Technical Service Information

4L80-E

ENGINE STUMBLE/STALL ON ENGAGEMENT

Figure 1

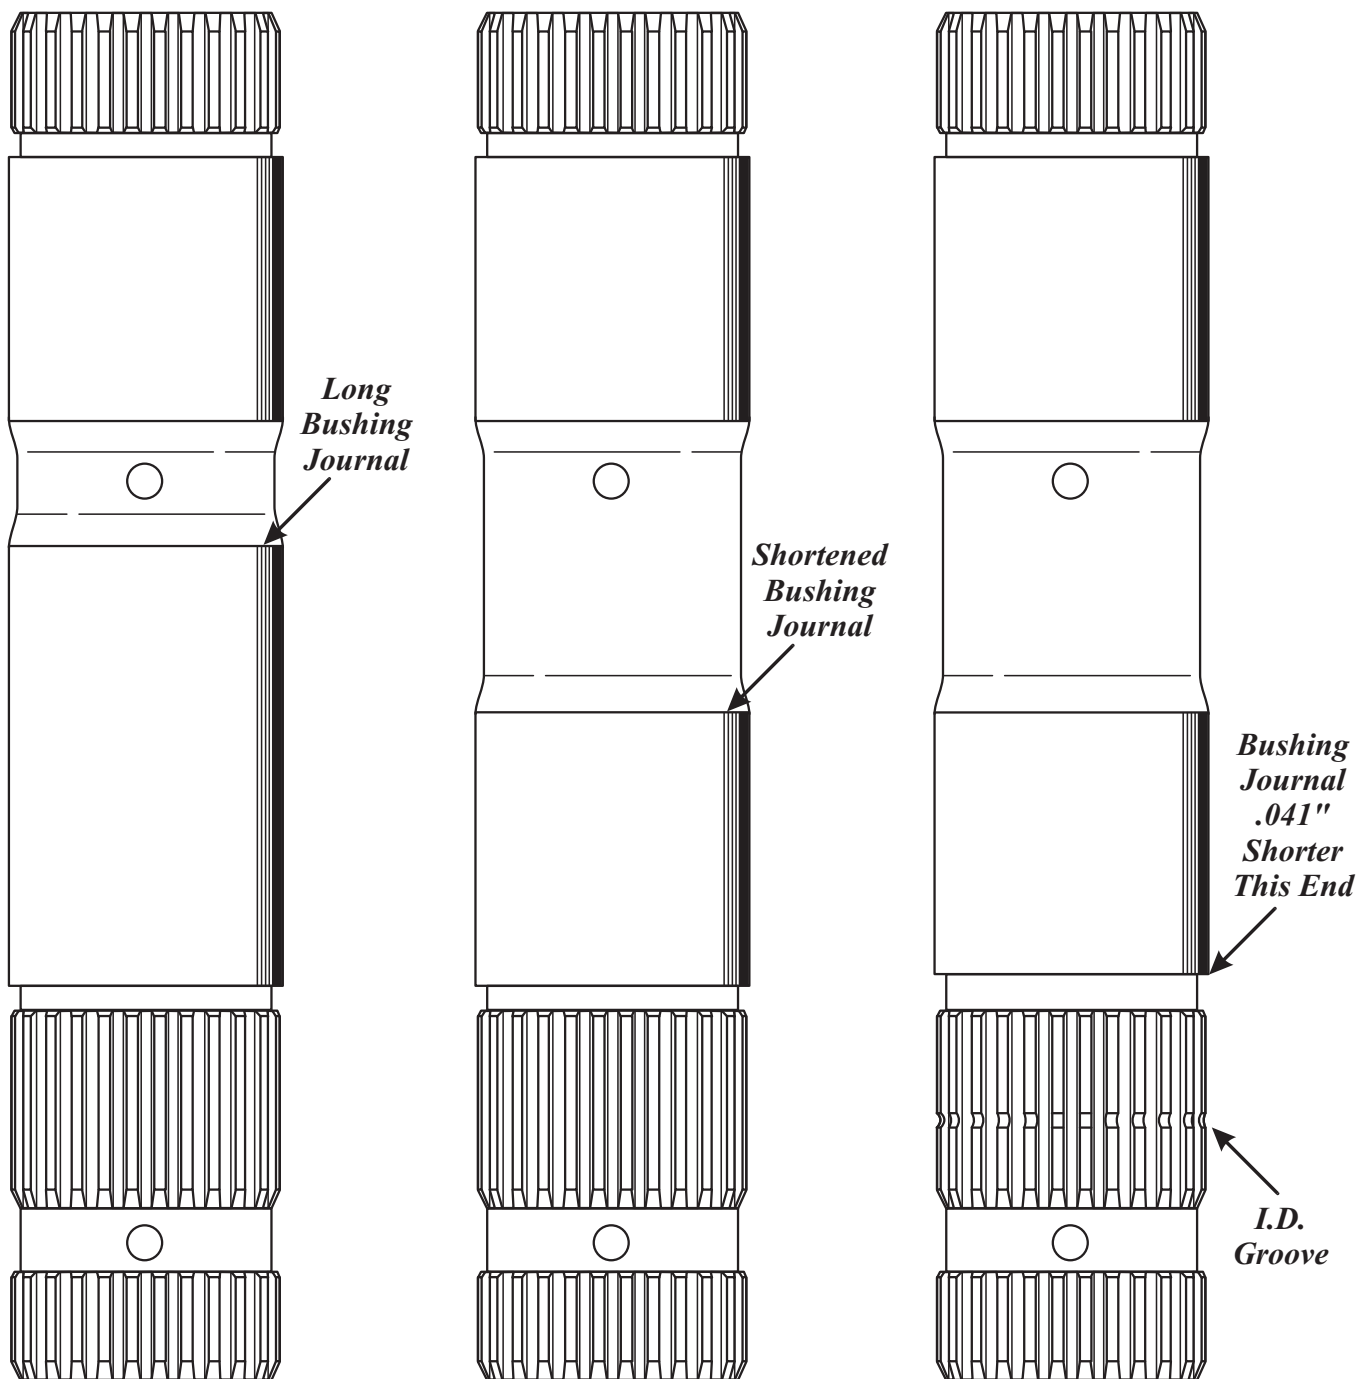
CAUSE: During the overhaul process the original 1997 or later design sun gear shaft was replaced with a 1996 or earlier design sun gear shaft. This was the only piece replaced in the main planetary gear train. All other related gear train parts remain original.

CORRECTION: The sun gear shafts used in 1997 and later center lube transmissions have a shortened bushing journal when compared to the earlier design. Using the earlier design shaft with the longer bushing journal will create a restriction in the oil cooler/lube circuit and cause the converter clutch to drag.

Replace the sun gear shaft with the proper part for your application. (See figure 1)

**1ST DESIGN LEVEL
SUN GEAR SHAFT
1991-96**

**2ND DESIGN LEVEL
SUN GEAR SHAFT
1997-98
PART NO. 24207247**

**3RD DESIGN LEVEL
SUN GEAR SHAFT
1999- UP
PART NO. 24207264**
